Re: **Site Assessment Workplan Addendum 2**  
Former Olympic Service Station  
1436 Grant Avenue  
San Lorenzo, California  
Fuel Leak Case No. RO00000373

## **RESPONSE TO ACEHD'S TECHNICAL COMMENTS**

**Soil Vapor Sampling  
Apparatus Diagram**

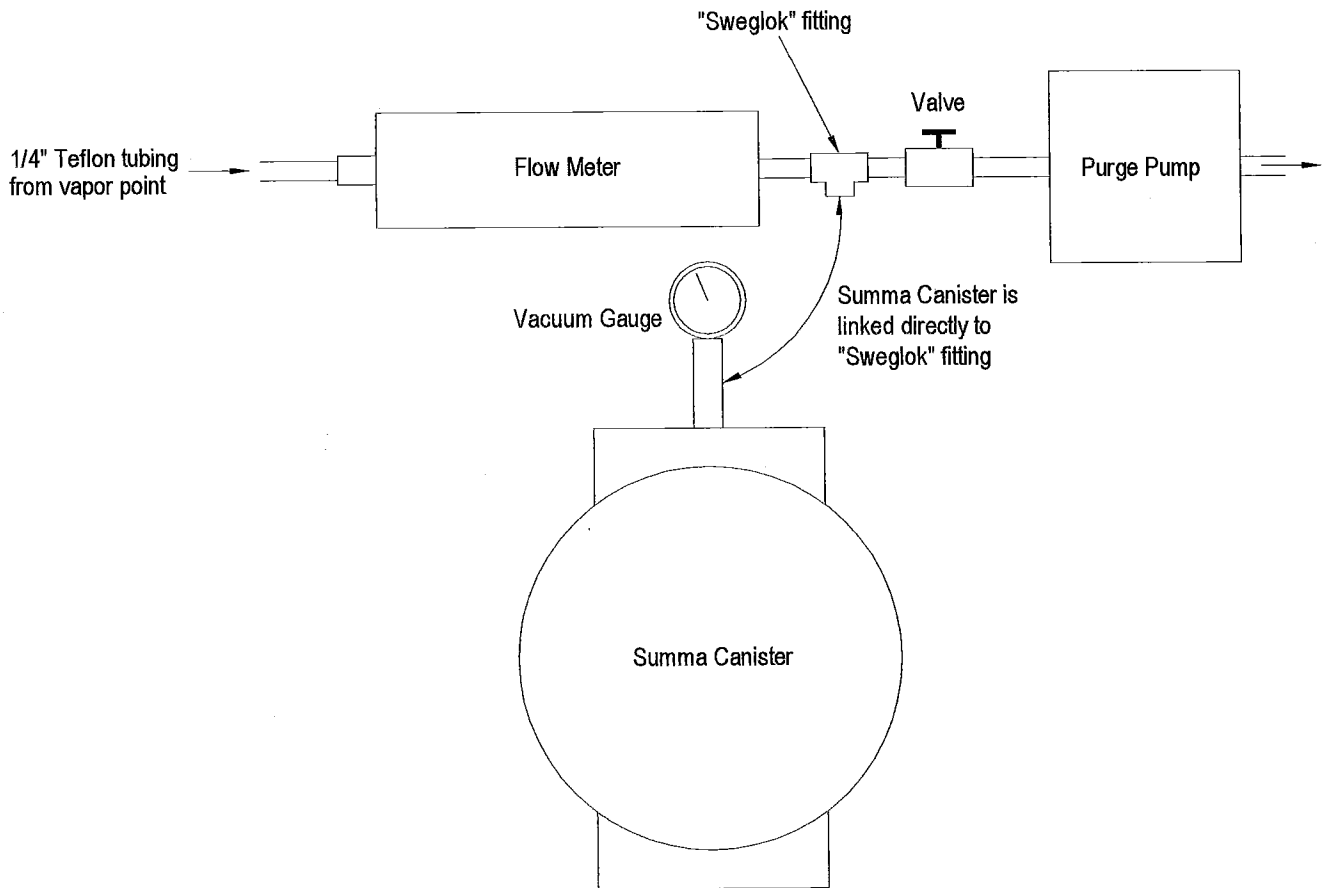
1. **Soil Vapor Sampling.** CRA asserts that based on low concentrations of TPH and TPH constituents in groundwater in onsite monitoring wells, soil vapor sampling should be deferred until the downgradient site assessment is completed. ACEH strongly disagrees with the contention that soil gas sampling should be delayed pending the evaluation of the results from the soil and groundwater investigation. Furthermore, soil data collected from soil borings BH-B and BH-C detected benzene at concentrations of 2.2 mg/kg and 1.7 mg/kg, which exceed the ESLs for residential land use.

Prior to the installation of soil boring, ACEH requires a soil vapor survey must be completed. Once the soil vapor investigation has been completed and the data evaluated, additional soil borings will be necessary to determine the downgradient extent of the dissolved petroleum hydrocarbon plume. Please prepare a revised work plan that describes your proposal to evaluate the vapor intrusion pathway in the report requested below.

A schematic of the above-ground soil vapor sampling apparatus is shown on Figure B. A measured volume of air will be purged from the tubing using a pump and a tedlar bag. A minimum of three tubing volumes will be purged from each soil vapor point prior to sample collection. Immediately after purging, soil vapor samples will be collected over an approximate 30-minute period using 1-liter Summa canisters and capillary air-flow controllers.
